CHANNEL 1 BILEVEL SWITCH CIRCUITRY

CROWN INTERNATIONAL, INC.					
1718 WEST MISHAWAKA ROAD ELKHART, IN. 46517 PHONE (219) 294-8000					
SCHEM, MA3600VZ B-L SW THC					
PRINTS TO	G	DRAWN	KLW	04-23-93	APPROVED BY :
CHECKED		ME			DO NOT SCALE PRINT
SCALE		NONE	EE		SUPERSEDES
PROJ #		D278	PE	RS	E.C.N.
NEXT ASSEMBLY					C.P.N.
					1-24-94
					J0561-1
					REV (B)

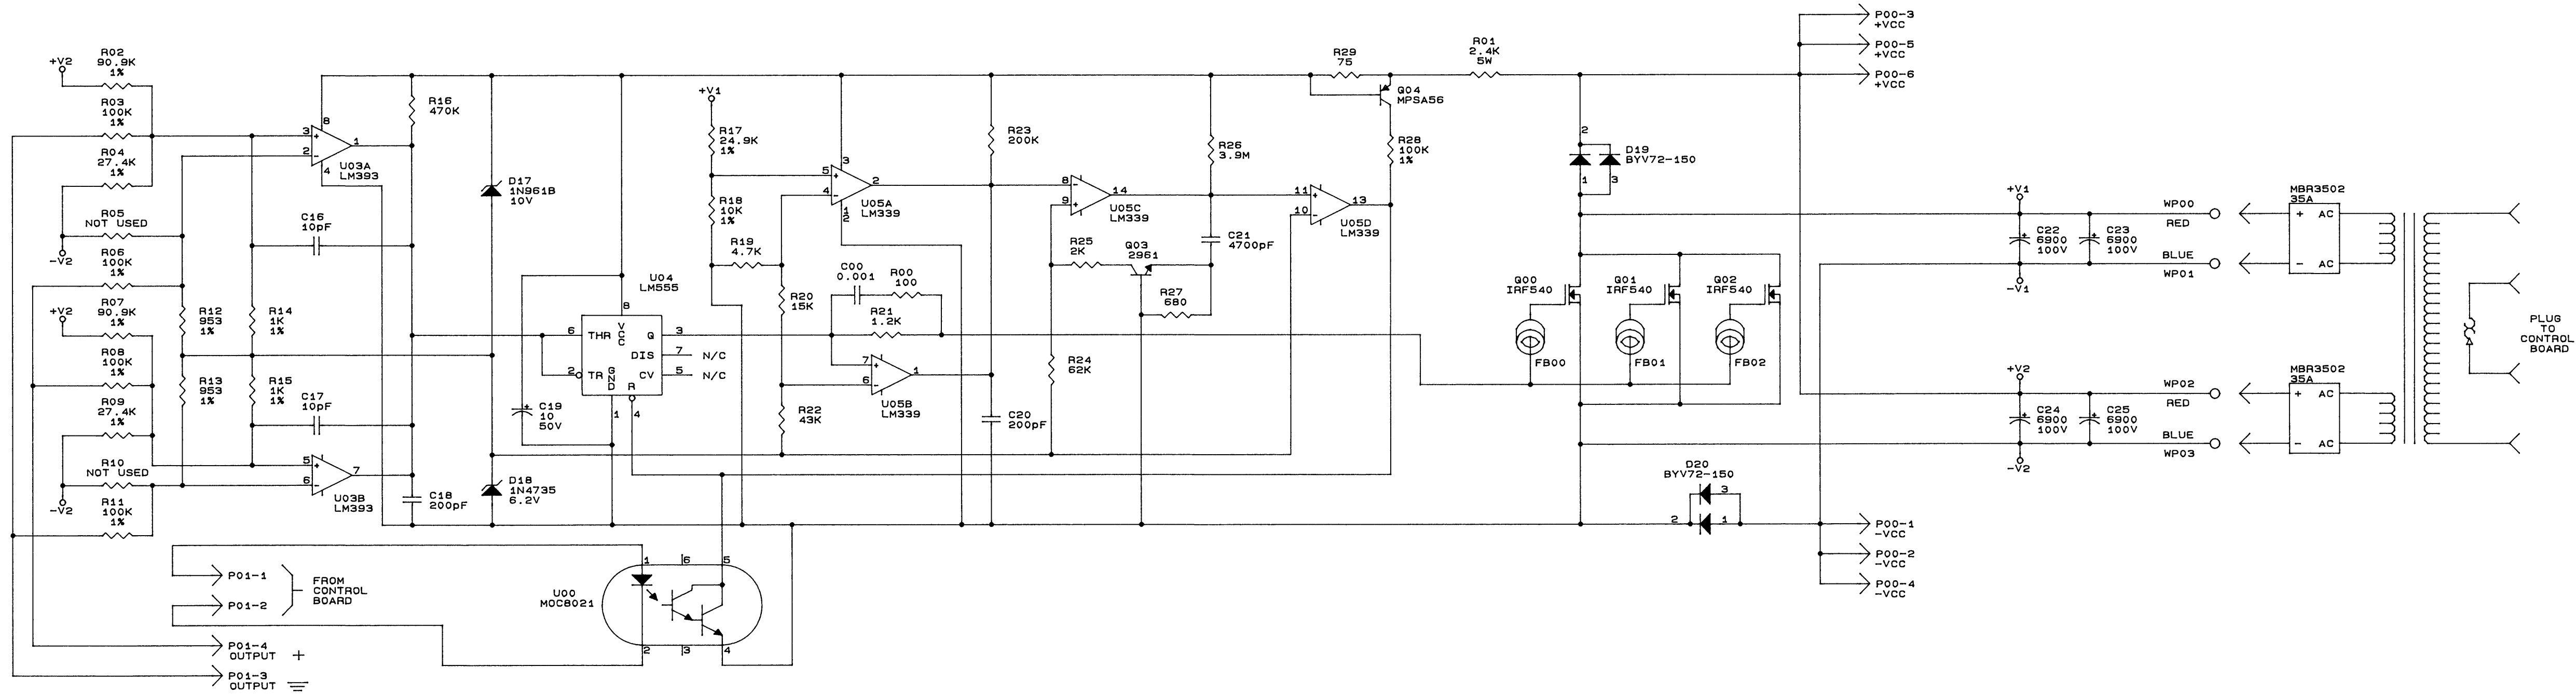
EAT #	ZONE	REV	DESCRIPTION	DATE	BY	APPROVALS		
		(A)	Q00-Q02 WERE IRF641. R17 WAS 68K. R18 WAS 5%. ADDED NOTE 5.	05-03-94	KLW	CK	ME	EE
94-124		(B)	ADDED Q04 AND R29. REVISED NOTE 5.	07-12-94	KLW			JW
